**Permitting and Support Centre
Quadrant 2
99 Parkway Avenue
Parkway Business Park
S9 4WF**

Our ref: 3982-CAU-XX-XX-CO-V-9001-A0.C1

Your ref: *EPR/NP3538MF/V009*

Re: Schedule 5 notice for Daneshill Soils Treatment Facility (permit ref: EPR/NP3538MF/V009)

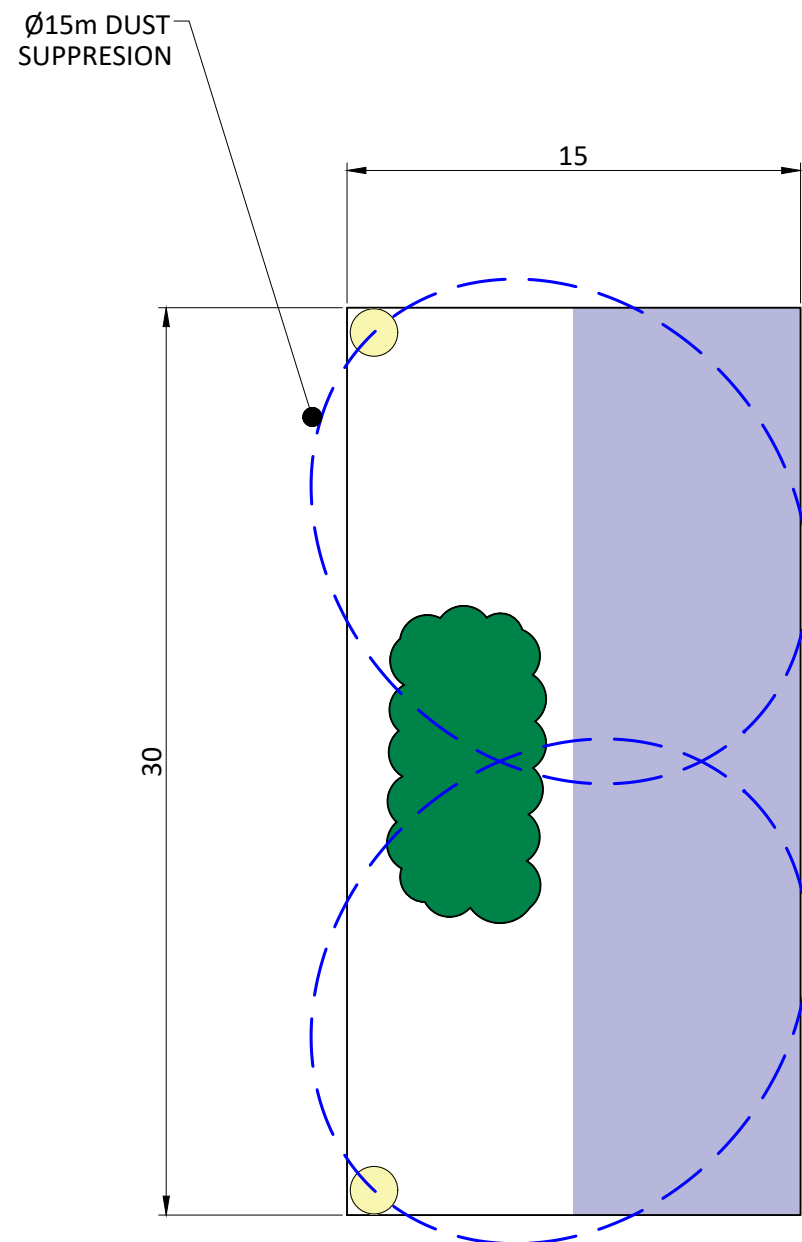
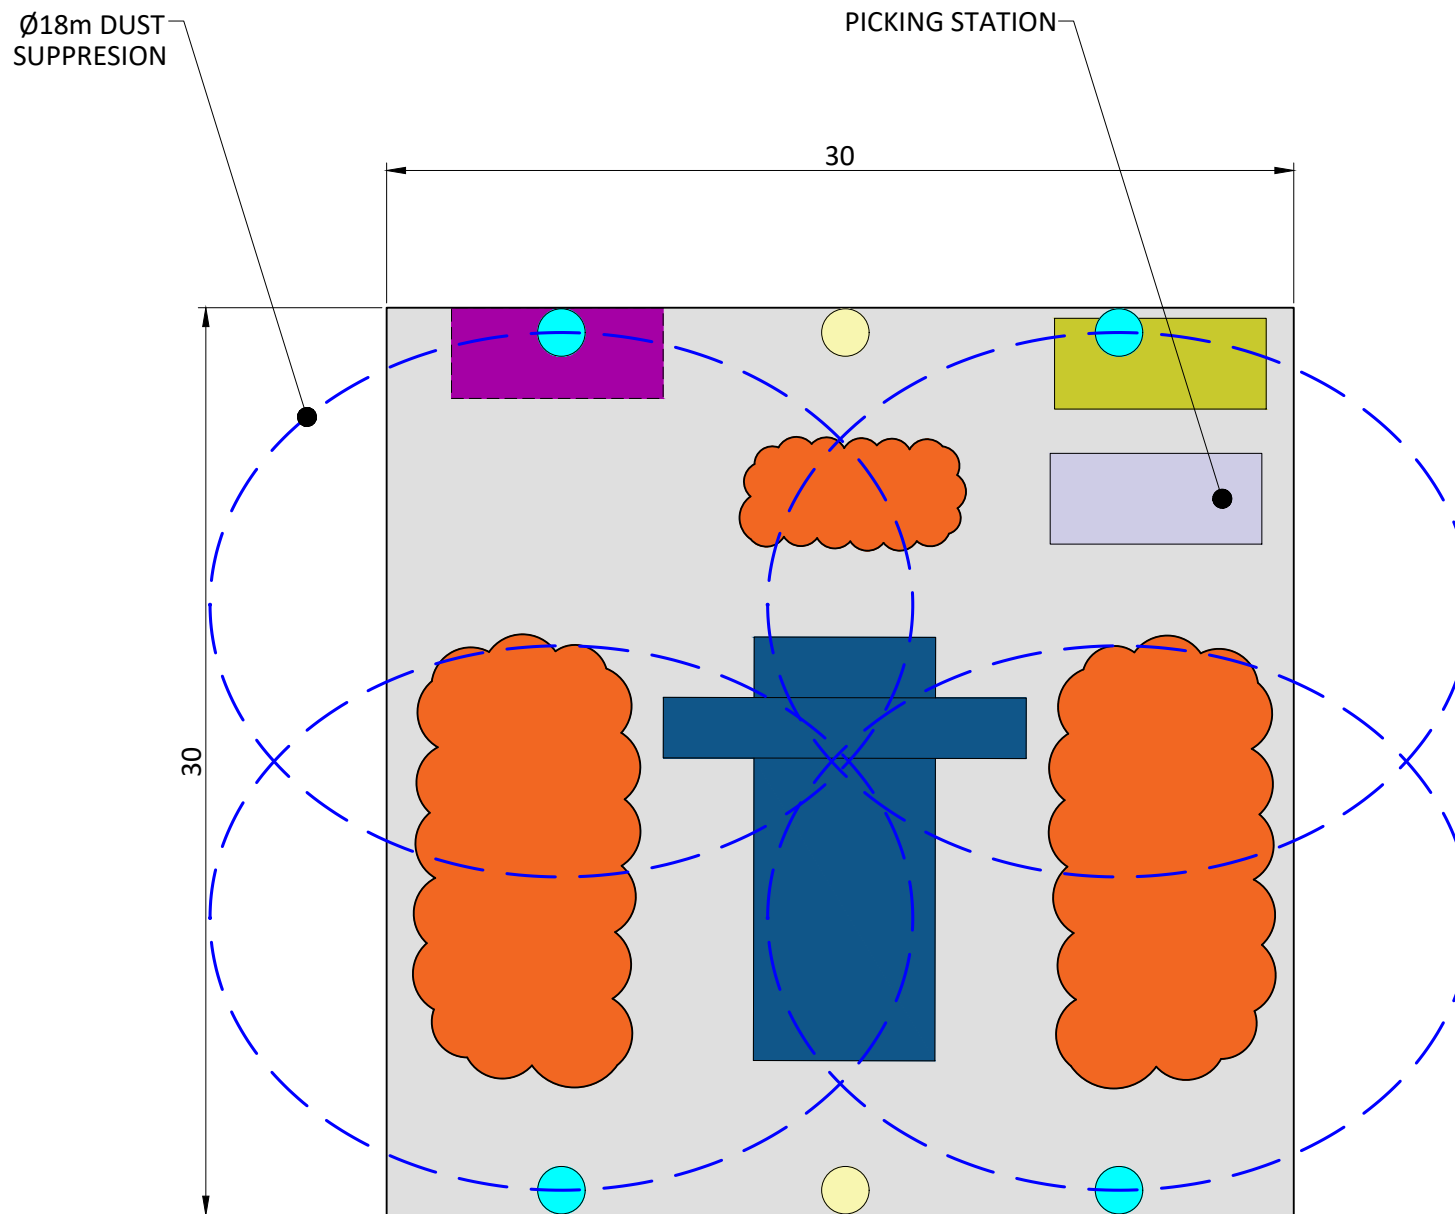
- 20) Clarify if all asbestos monitoring locations have been identified on plan 3982-CAU-XX-XX-DR-V-1803. Revise the plan if necessary.**

Reason – This plan details 4 boundary locations. Table 2 of the EMP confirms monitoring is also undertaken around the treatment area during screening. These locations must also be included.

- 44) Revise the emissions monitoring plan to include the visual monitoring locations for dust, the locations of the Frisbee gauges and the VOC monitoring location. The locations of the asbestos pumps to be located around the working area during soil moving must also be included.**

In addition to drawing ref: 3982-CAU-XX-XX-DR-V-1803, Emissions Monitoring Plan for Dust Asbestos and VOCs, Drawing ref: 3982-CAU-XX-XX-DR-V-1812 shows sampling locations positioned to act as source area sampling points; it is to be noted that several sampling points will be pooled to form an individual sample due to the high volume of air (typically 1,440l) required to achieve the asbestos detection limit of <0.0005f/ml.

See Emissions Monitoring Plan for Dust Asbestos and VOCs Drawing ref: 3982-CAU-XX-XX-DR-V-1812.

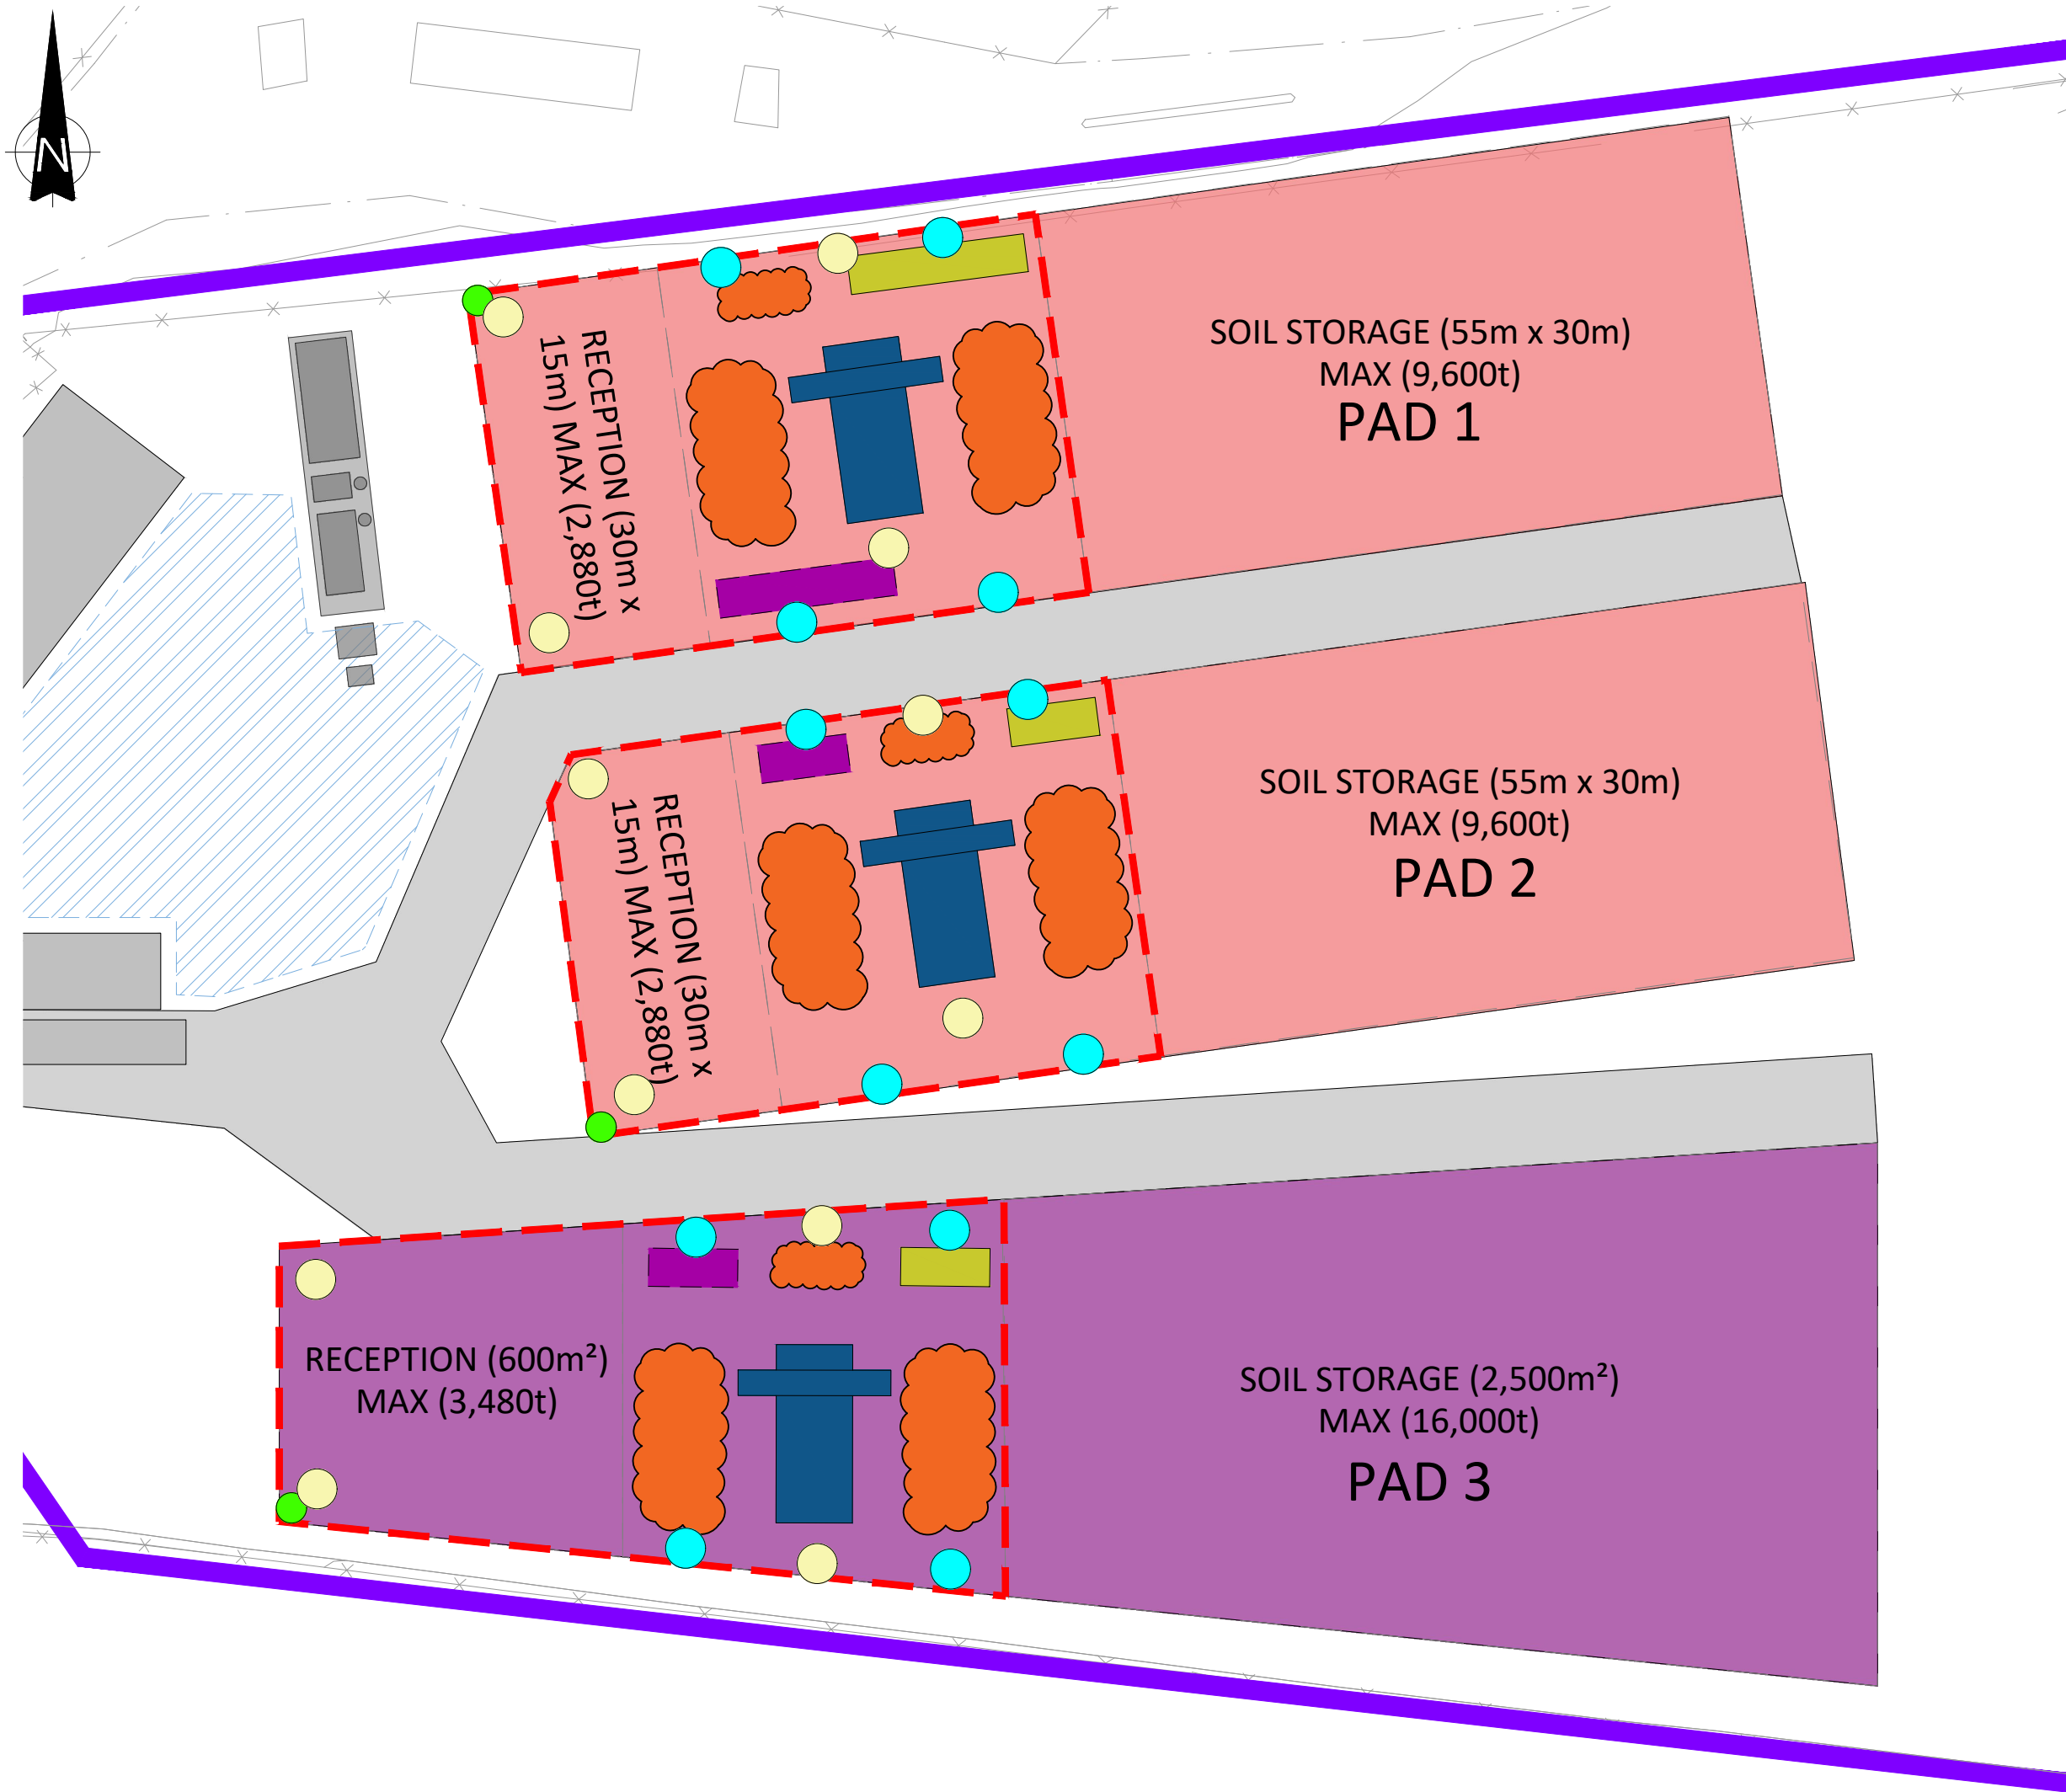
- 38) **Provide details of the water based suppression system in more detail including:**
- **Which stockpiles have water sprinklers (show these on the site plan)**
 - **If suppression is provided within the picking booth (6.1.23 indicates this but no further detail is provided)**
 - **Explain if the sprinkler on the screener is fixed into position or mobile**
 - **Explain if the stockpile sprinklers are fixed into position**
 - **Explain if they are fed from water storage or mains**

Demonstrate there is sufficient supply and pressure to provide water to all the sprinklers and cannons as necessary

In addition to the soil treatment area, the stockpiles with uncovered untreated soils will be subject to dust suppression by water based dust suppression plant. Please see 'Suppression Systems Location'

Drawing ref: 3982-CAU-XX-XX-DR-V-1810 and 'Suppression System Spray Arcs', Drawing ref: 3982-CAU-XX-XX-DR-V-1811

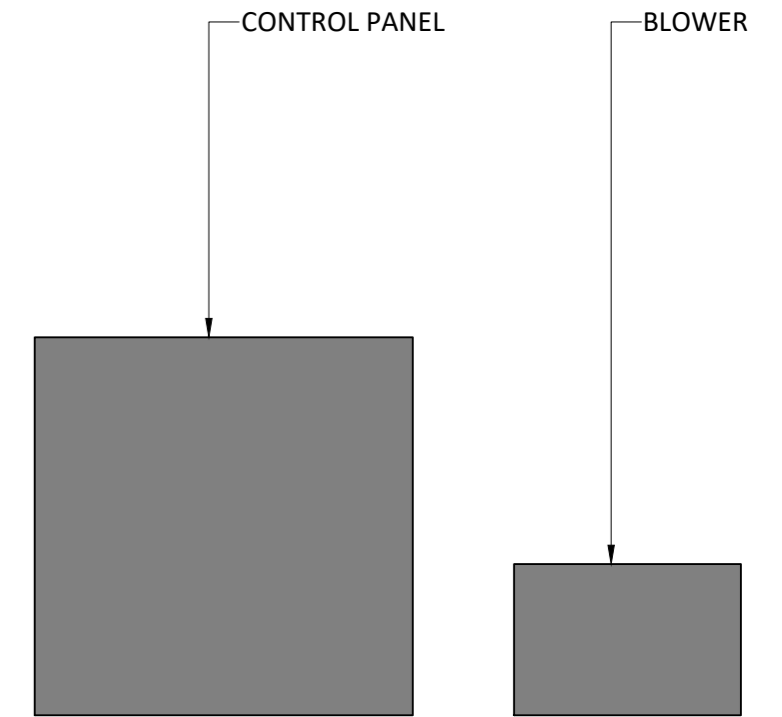
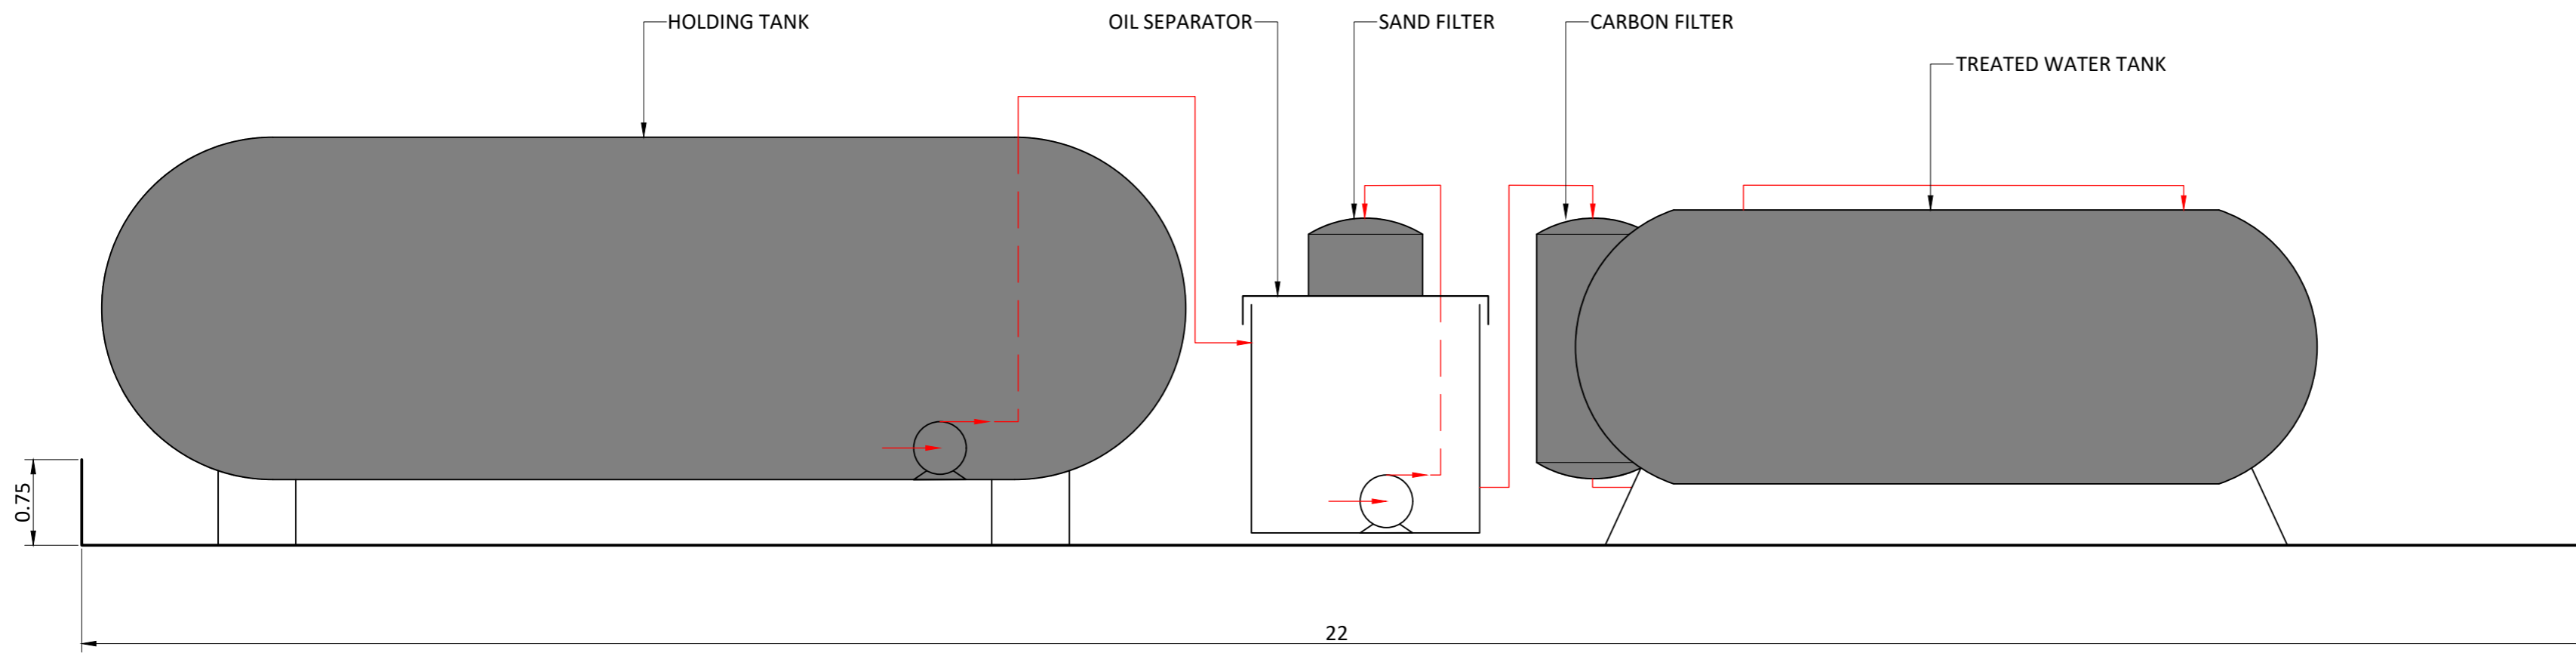
- 5) ***Explain the containment measures provided for the water treatment compound, waste, raw materials and fuel storage areas. Include these on the revised plan***

31) Provide the design details of the tanks including pipework and containment.

Water Treatment Compound – waste, raw materials and fuel storage areas as shown in drawing ref: 3982-CAU-XX-XX-DR-V-1809.

The design details are shown on the drawing attached (to follow). The largest tank in the water treatment area is 50m³ and so would require a minimum of 55m³ of bunded capacity. The pipework between tanks comprises of 50mm fusion welded HDPE to ensure the highest possible leak protection.
